Synchronizing CRU BW and Jitter Tolerance for 100GBase-LR4/ER4

September 21, 2009

Ali Ghiasi, Afshin Momtaz, Magesh Valliappan
Broadcom Corporation
aghiasi@broadcom.com

10 GbE/100GbE Jitter Tolerance Masks

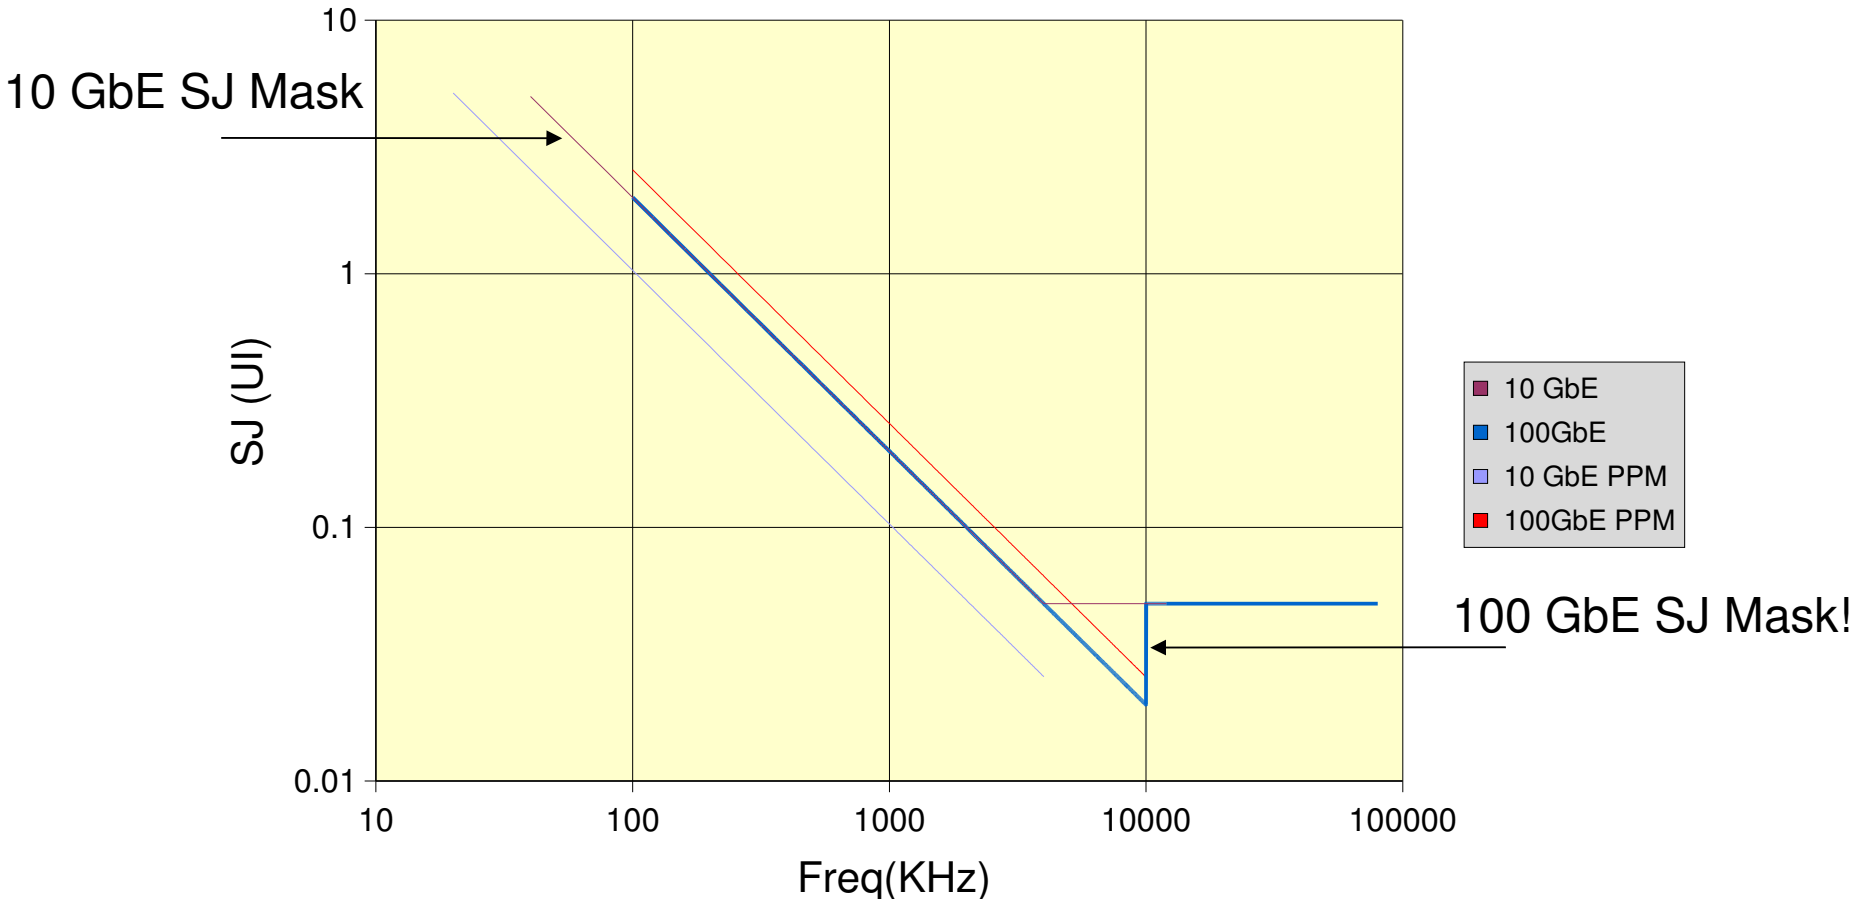
- **88.8.5.3 Reference Receiver, defines CRU used for TDP measurement has 10 MHz BW**
- **88.8.8 Transmitter optical waveform, is defined with CRU with 10 MHz corner frequency**
- **88.8.10 Stress receiver sensitivity, table 88-13 effectively defines a 4 MHz CDR corner frequency**
- **The corner frequency for TDP, transmitter optical waveform, and stress receiver must be the same.**
- **Current definition allow more stress into the link but the receiver is not fully tested to the maximum SJ stress.**
 - **With current definition just the +/-100 PPM offset can exceed the SJ tolerance mask.**

- Current 100 GbE mask is broken and even the PPM offset exceeds the mask

- **The current specifications is clearly broken!**
- **What are the options**
 - **Use 10 GbE mask with 4 MHz corner frequency for transmitter CRU and jitter tolerance, “4 MHz Option”**
 - **Change table 88-13 2×10^5 coefficient with 5×10^5 , “10 MHz option”**
 - **Take a compromise position with 7 MHz corner frequency for the CRU and jitter tolerance, “7 MHz option”**
 - **Lowest transmitter jitter was for BW of 5 to 7 MHz**

SerDes Transmitter Relative Jitter

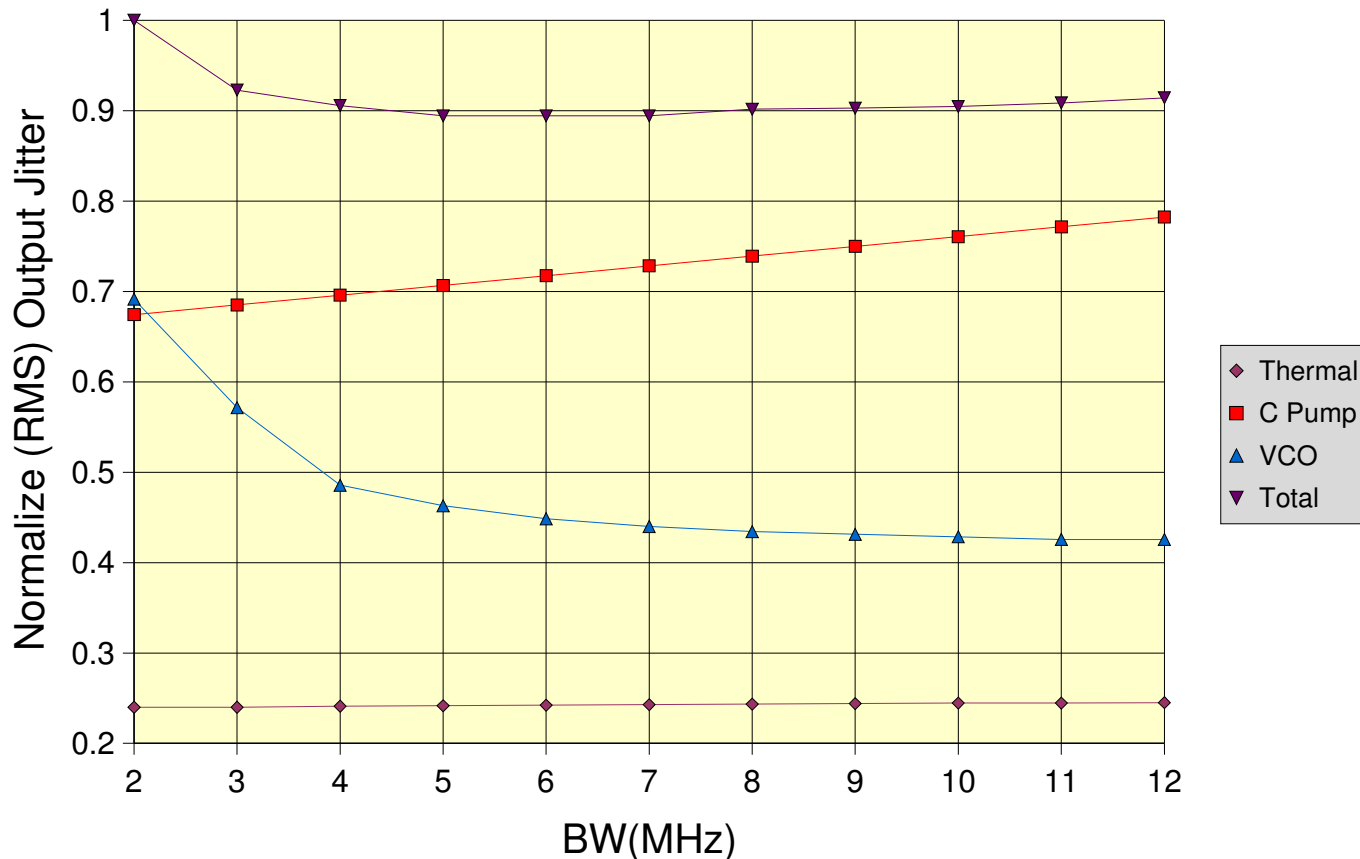
- Thermal, charge pump, VCO, and total relative output jitter as function of BW
 - BW of 5-7 MHz gives best total output jitter

10 GbE SJ Mask and Proposed 100 GbE Mask

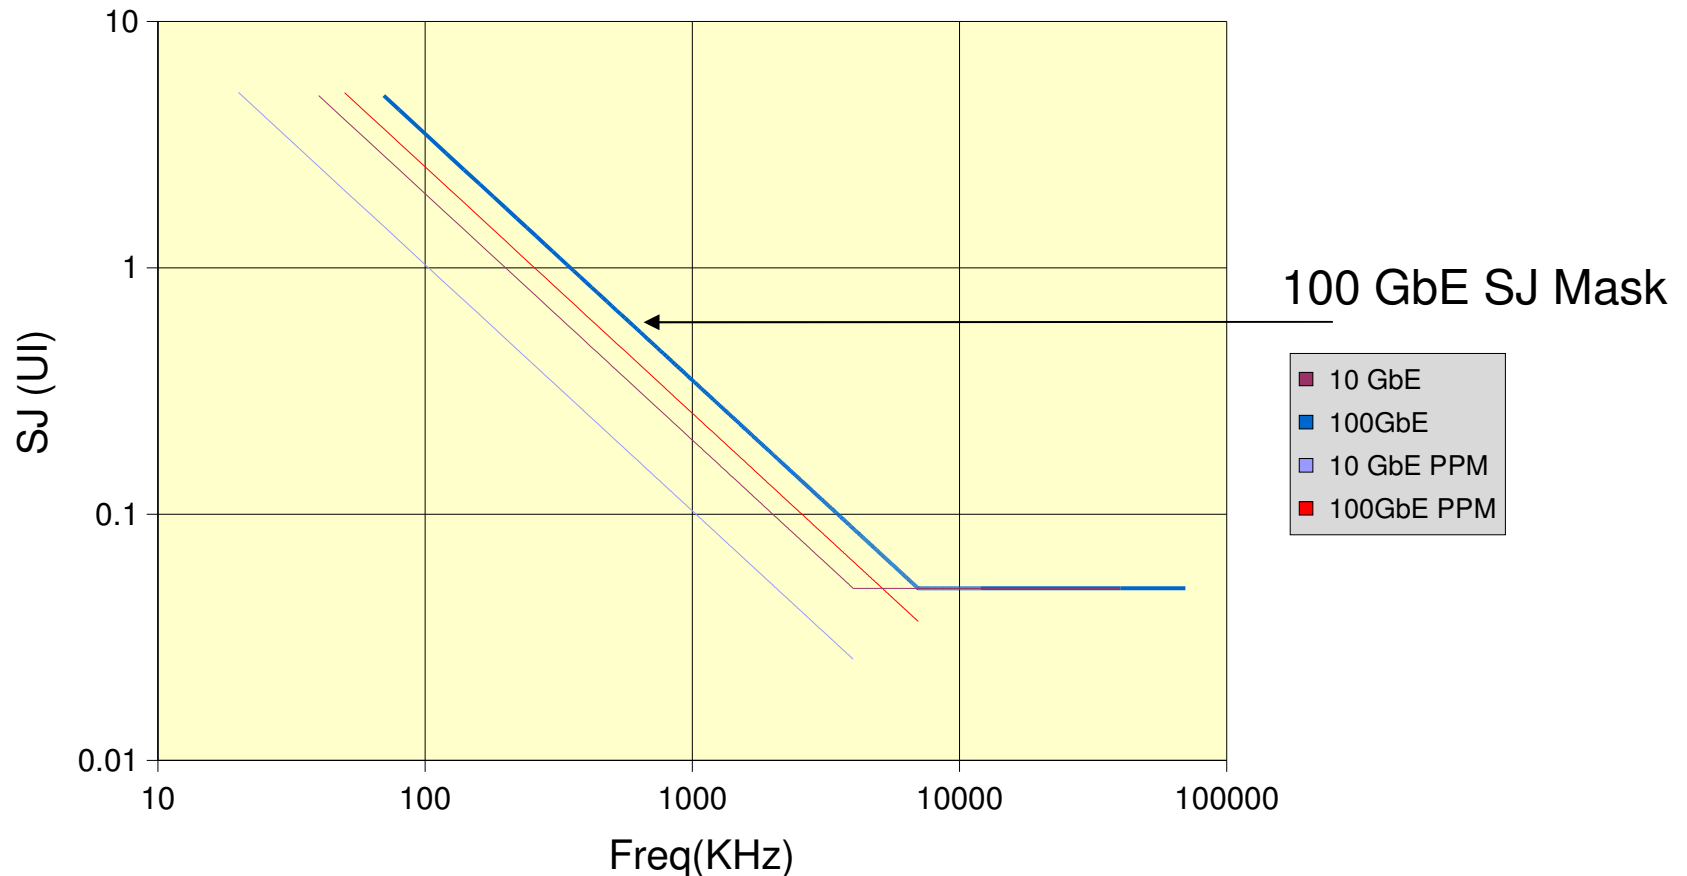
- 100 GbE mask with proposed compromised 7 GHz BW

- The combination of current CRU+SJ specifications is busted and must be changed!
- The 7 MHz CRU and SJ corner frequency is a compromise between the current 10 MHz CRU BW and 4 MHz SJ corner frequency
 - 5-7 MHz BW results in the lowest output jitter
 - SJ corner frequency of ≤ 7 MHz allow lower cost and power de-serializer options
- Proposed resolution assuming 7 MHz for CRU and SJ corner frequency
 - Change 88.8.5.3 and 88.8.8 CRU BW from 10 MHz to 7 MHz
 - Change 88.8.10 SJ corner frequency from 4 MHz to 7 MHz
 - $f < 70$ KHz \Rightarrow not specified
 - $70 \text{ KHz} \leq f \leq 7 \text{ MHz}$ $\Rightarrow 3.5 \times 10^5 / f + s - 0.05$
 - $7 \text{ MHz} < f < 10 \text{ LB}$ $\Rightarrow 0.05 \leq S \leq 0.15$
